# 2nd Gen Indoor Station Firmware

## V2.1.46\_build220607 Release Note

Device Model	DS-KH8350-WTE1、DS-KH8350-TE1、DS-KH6320-WTE1、DS-KH6320-WTE2、DS-KH6320-WTE2(B)、DS-KH6320-TE1、DS-KH8520-WTE1
Firmware Version	V2.1.40_build220607
iVMS-4200 Version	Latest version
Hik-Connect APP	Latest version

### Wizard-Indoor Station Settings 3/5

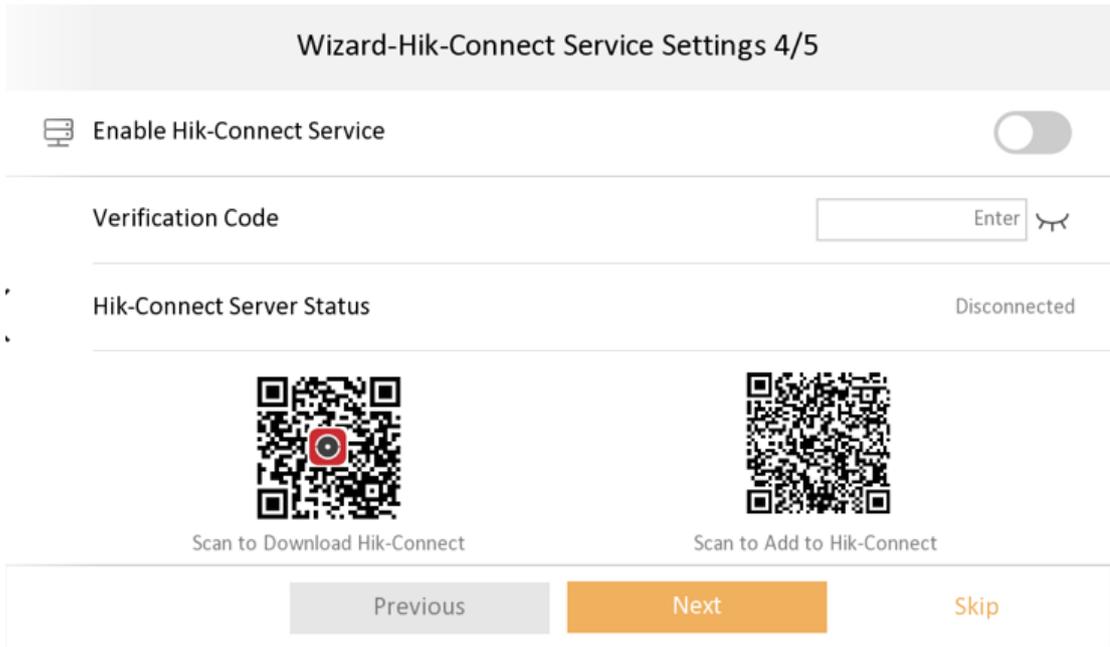
1. Optimize registration password settings in Wizard.

**Registration Password** Not configured. >  
 Be consistent with the activation password.  
When enabled, the people who has the registration password will have the device admin permissions.

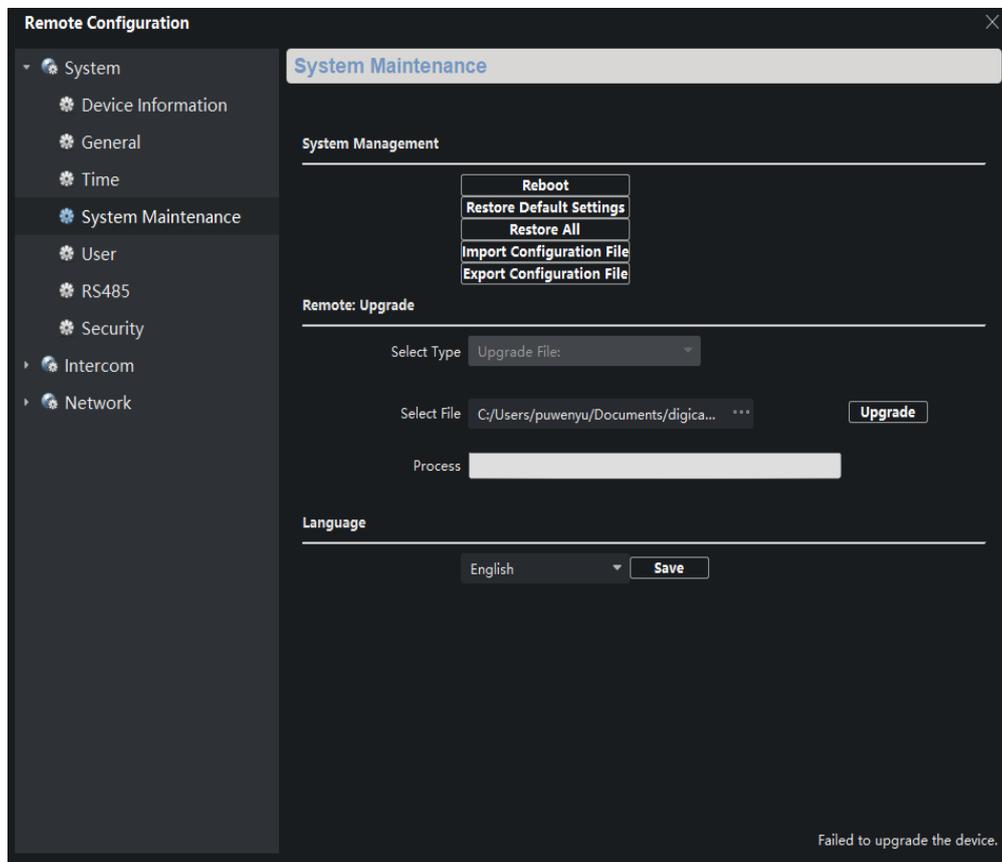
2. Hik-Connect Service Settings is changed to the place of Settings→ Advanced Settings→ Configuration→ System Maintenance.

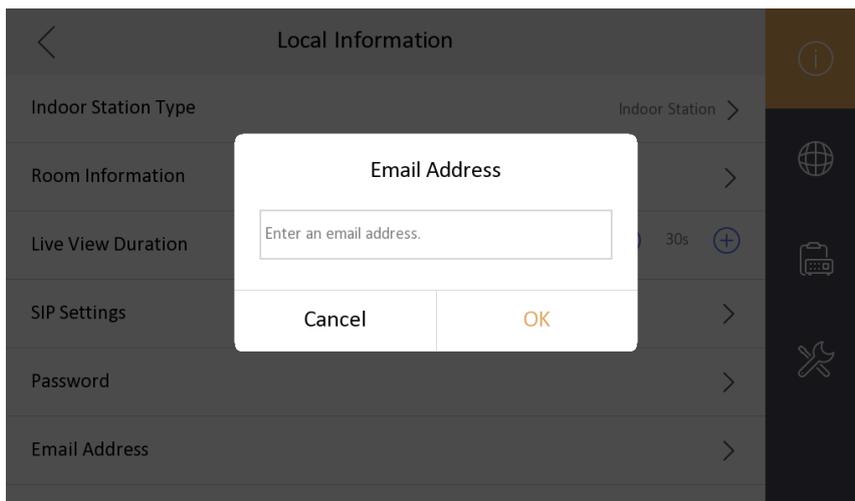
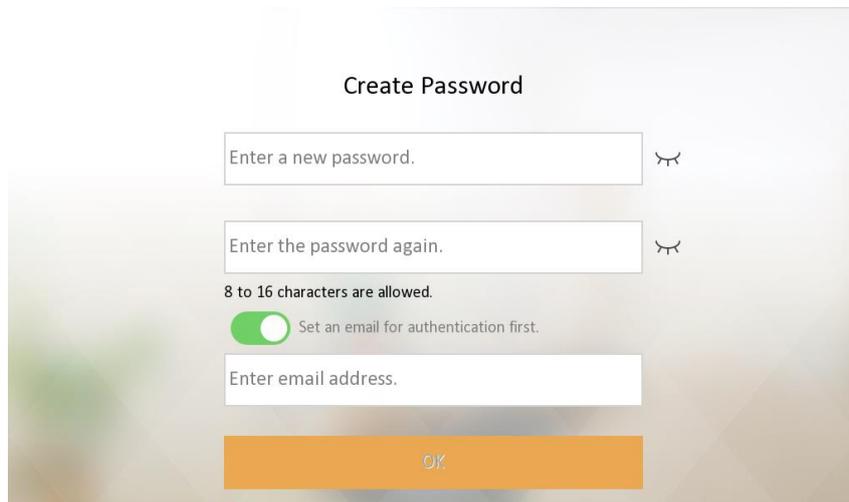
1. Local interface support to modify the password through email authentication

2. Support Hik-Connect configuration, closed by default

## Add Device

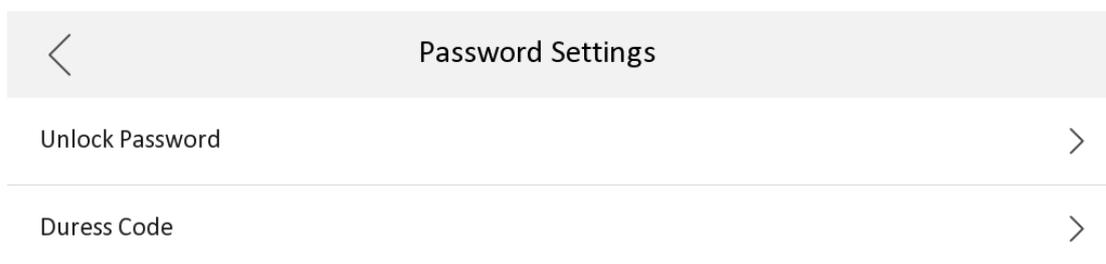
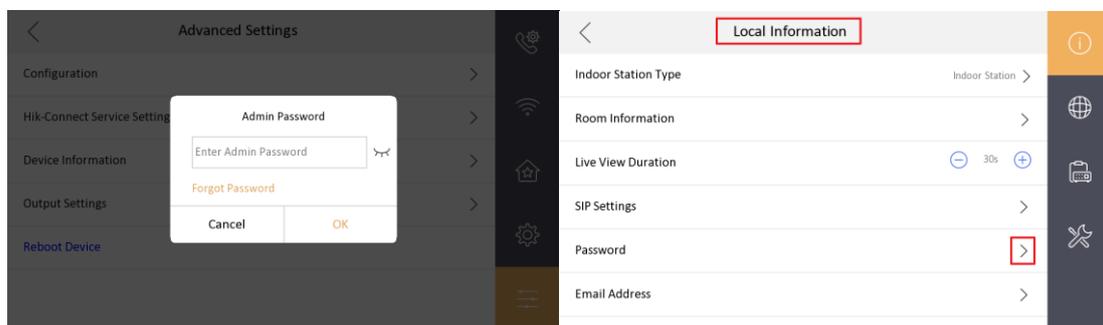
3. Newly added multi-language Croatian, Dutch, Romanian, Czech, Bulgarian, Croatian, Serbian
4. Add IPC interface, when Open Network Video Intercom protocol is selected, add plaintext ciphertext switch menu item configuration

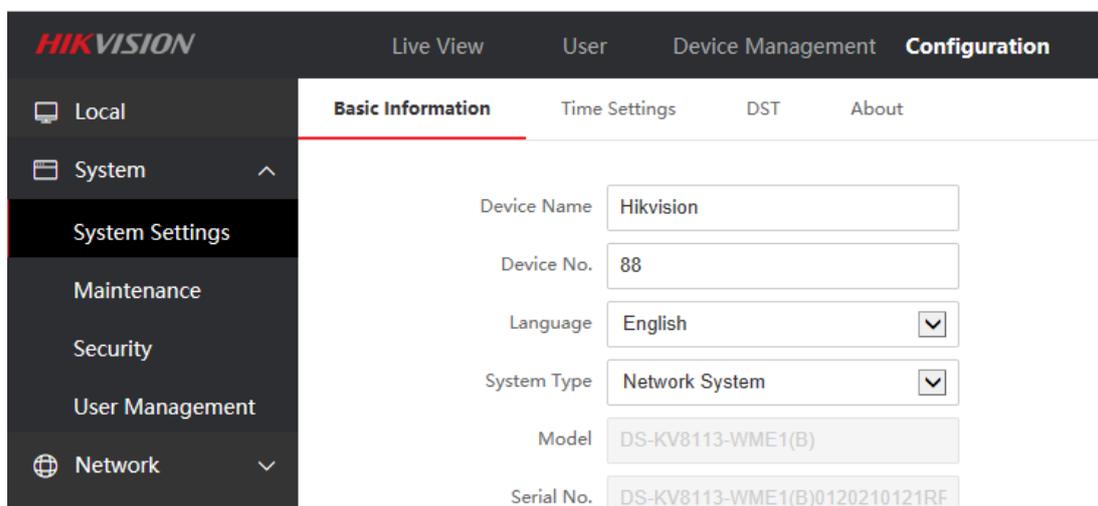
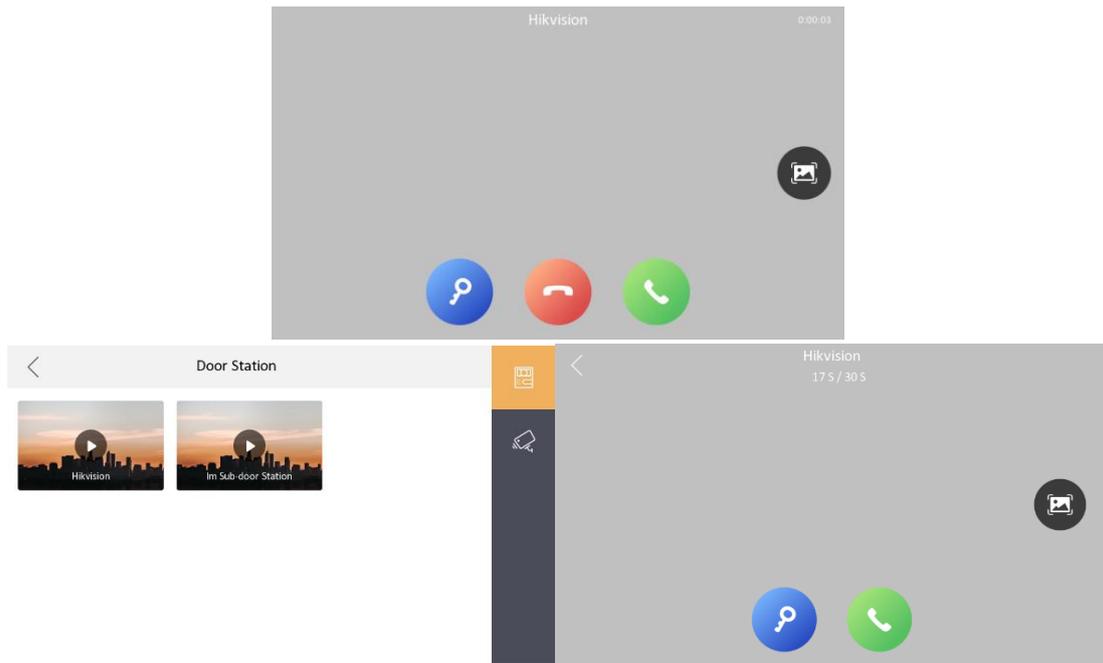
1. Change the position of unlock password and duress code, to enter the password page requires an admin (activation) password.

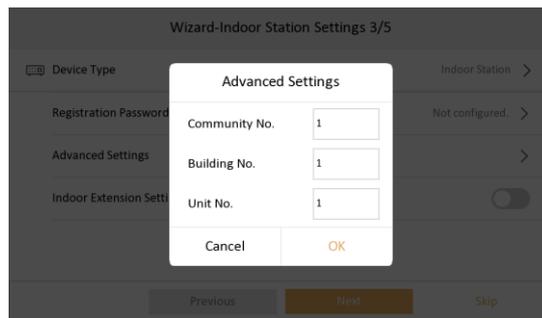
2. When changing the unlock password and duress code, the old password is not required as a credential.
3. The name of the local private SIP password configuration Sip Password is uniformly changed to Registration Password
4. The changed name of the door station(KD8003 modular door station, KV(-B), KB8113) will be displayed on the call interface or live view interface of the indoor station

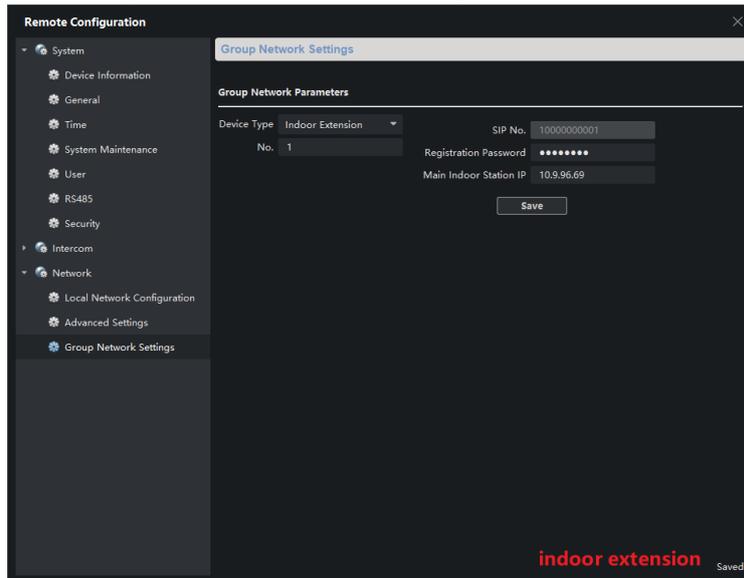
- The local interface community number, building number, and unit number of the indoor station will be stored in the advance column instead of being displayed directly

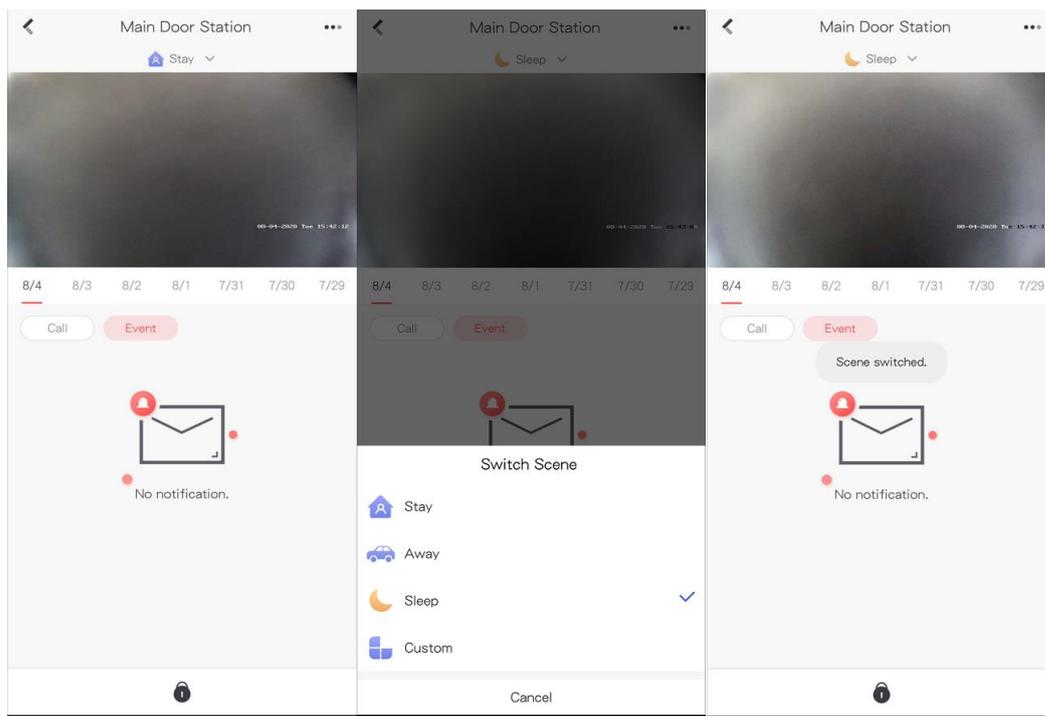
1) Support three formats in Settings->General Settings->Time and Date interface, set year-month-day, day-month-year, month- day - year

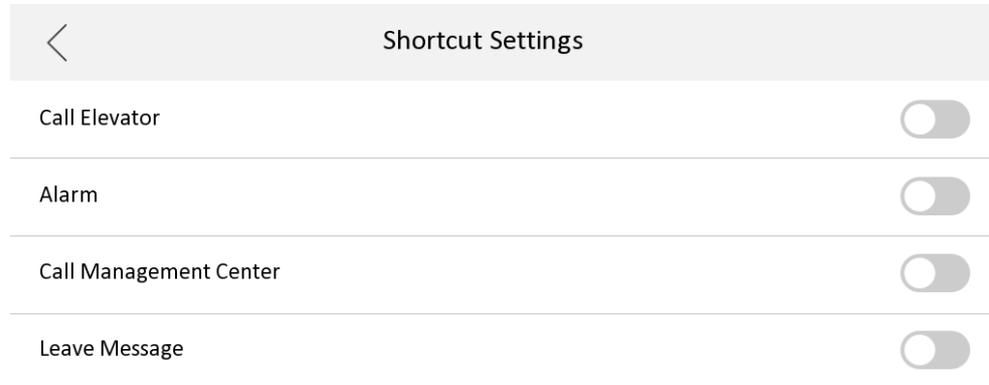
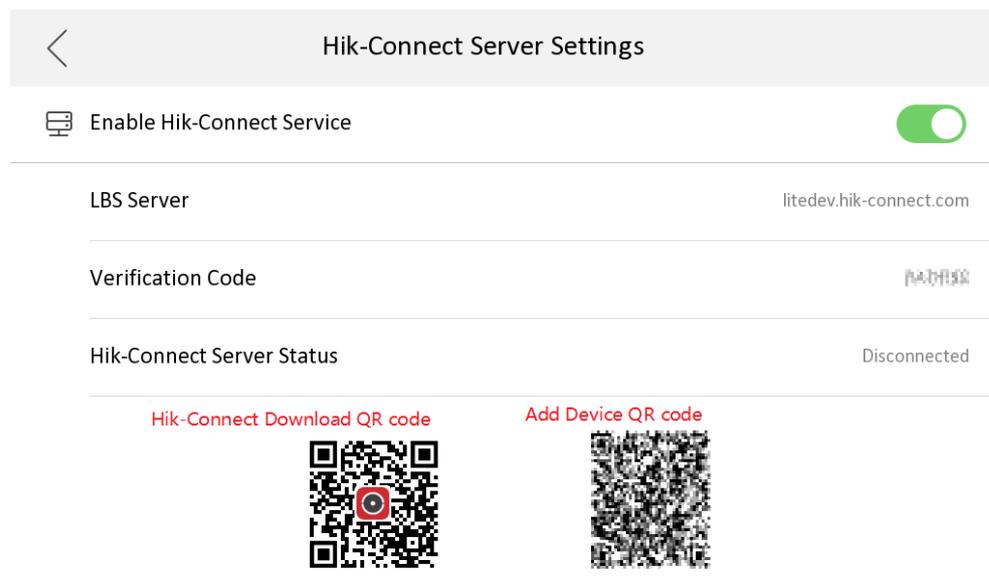
6. Support whether to enable the leave message function, it is disabled by default

1) In the Settings->More->Preference->Shortcut Settings interface

## Hikvision Video Intercom v2.0 Protocol

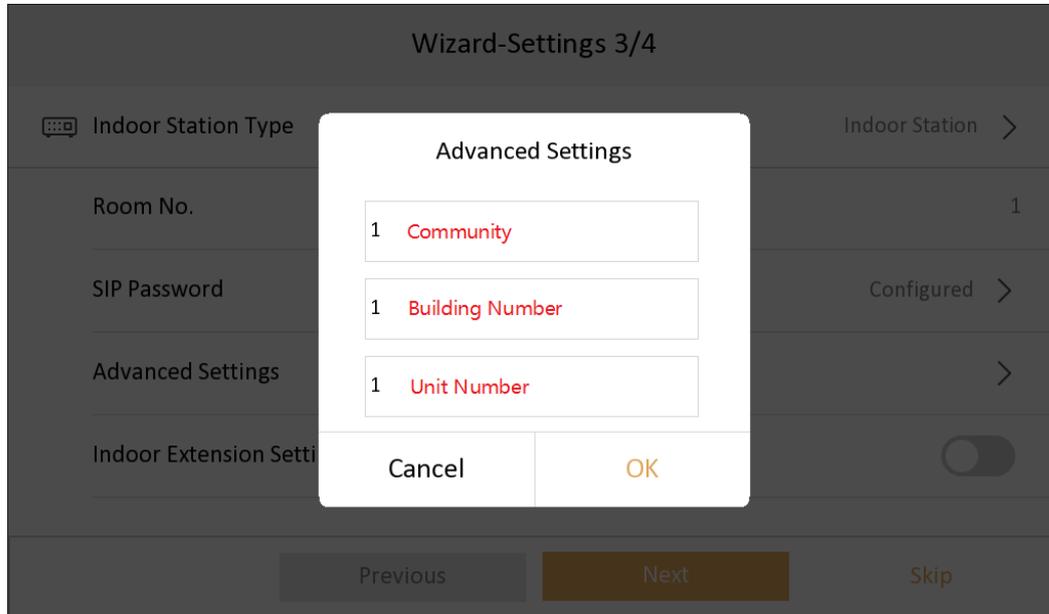
The communication protocol between Hikvision devices uses a secure private call protocol, and the communication with 3<sup>rd</sup> party devices uses standard SIP;

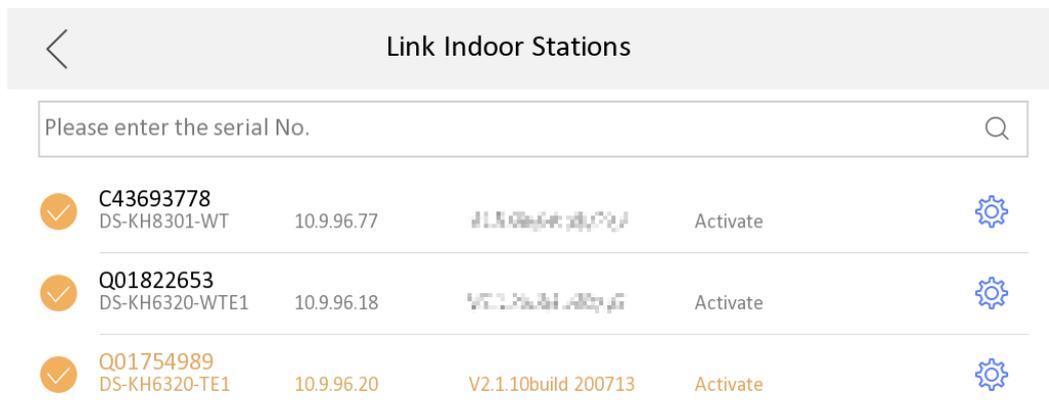
1) Support setting period number, building number, and room number on the indoor station;

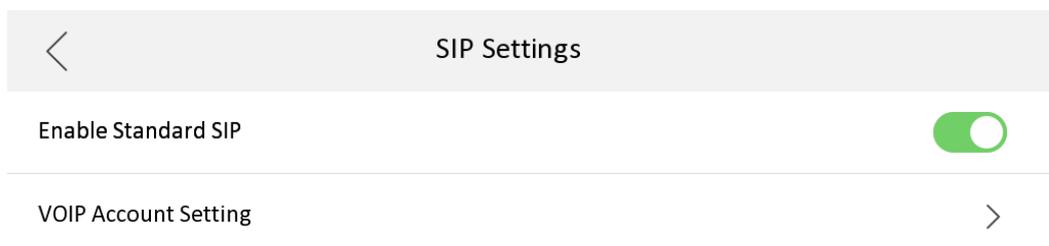
a) The indoor station does not need to switch to SIP mode;

b) The standard SIP of the indoor station is disabled by default, if you want to connect to a third-party standard SIP device, you need to turn on this function.

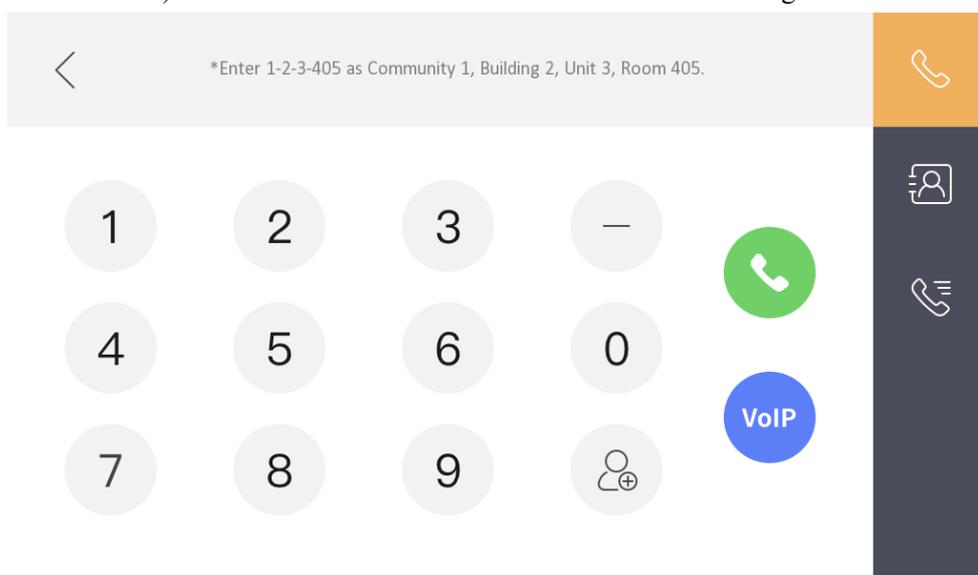
c) A standard SIP registration status icon is added to the main interface, which can be displayed/hidden according to whether standard SIP is enabled;

d) Added a VoIP call button in the call interface to distinguish standard SIP calls
